[copied from Council website, in case they again revamp website and lose historic material
http://www.edinburgh.gov.uk/info/20135/cycling_projects/503/meadows_-_innocent_path_ncn1/4

Meadows - Innocent Path (NCN1)

Consultation findings

Note: this is the map BEFORE the consultation results.

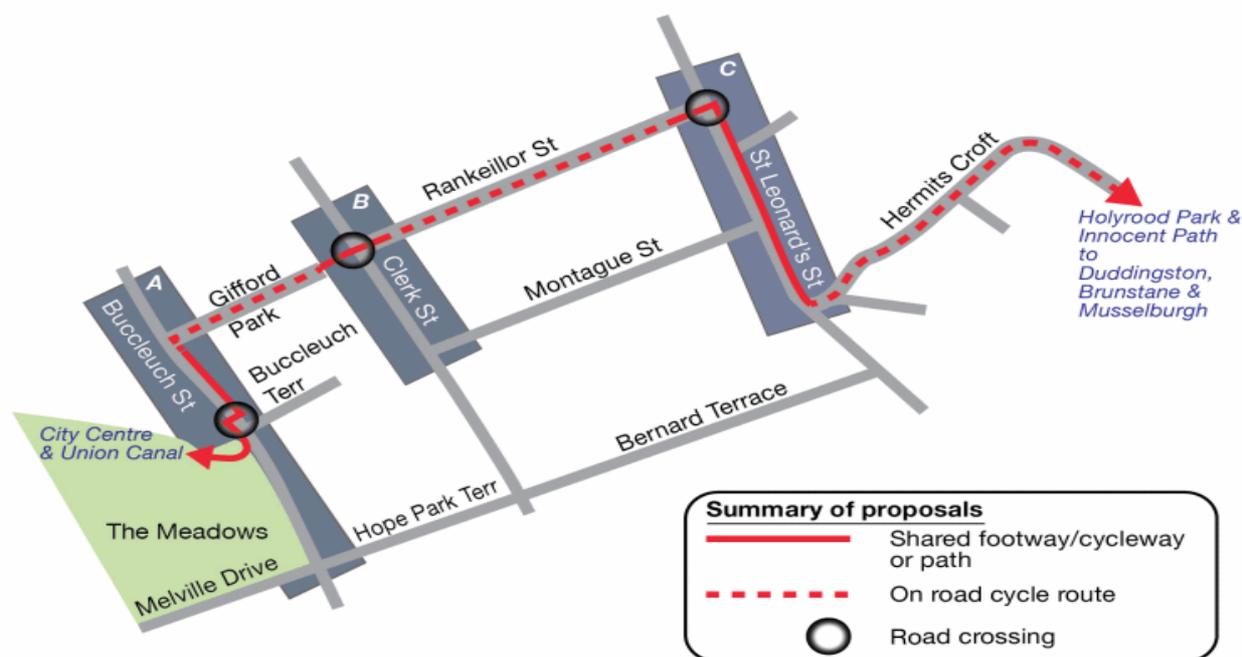
The largest single source of comments was about the sharing of space between pedestrians and cyclists. This was reflected in the most popular suggestion, which was that the cycle facilities should be segregated.

The new crossing on Buccleuch Street has been moved to be opposite the entrance/exit to the North Meadow Walk Path thereby eliminating the west section of shared footway/cycleway on Buccleuch Street.

The original proposal for the east side of St Leonard's Street, between St Leonard's Lane and Hermits Croft, had the existing footway designated as a shared space between pedestrians and cyclists. The revised layout has, by building out onto the carriageway in places, provided space to allow for a segregated cycle path and a separated pedestrian only footway.

The designers of the route are aware that cyclists emerging from Gifford Park onto Clerk Street have, due to position of existing buildings, a very restricted view to observe pedestrians approaching the repositioned crossing on Clerk Street. 'Road' markings and signage will therefore be installed to instruct cyclists to stop at the end of Gifford Park prior to Clerk Street and wait there until the crossing's pedestrian and cycling aspect is activated. To dissuade cyclists from waiting on Clerk Street and obstructing pedestrians a Toucan push button controller will be installed at the end of Gifford Park.

In light of comments received, the design has been modified to significantly reduce the length of shared footway/cycleway and increase the length of segregated cycle path.

Additional measures, including footway markings and tactile paving, will be installed on Clerk Street, on either side of the entry to Gifford Park to bring to the attention of pedestrians and the visually impaired that they are about to enter an area on which there may be cycling activity.

New raised tables will be installed across Buccleuch Street, St Leonard's Lane and Hermits Croft to give pedestrians and cyclists greater priority and reduce traffic speeds.
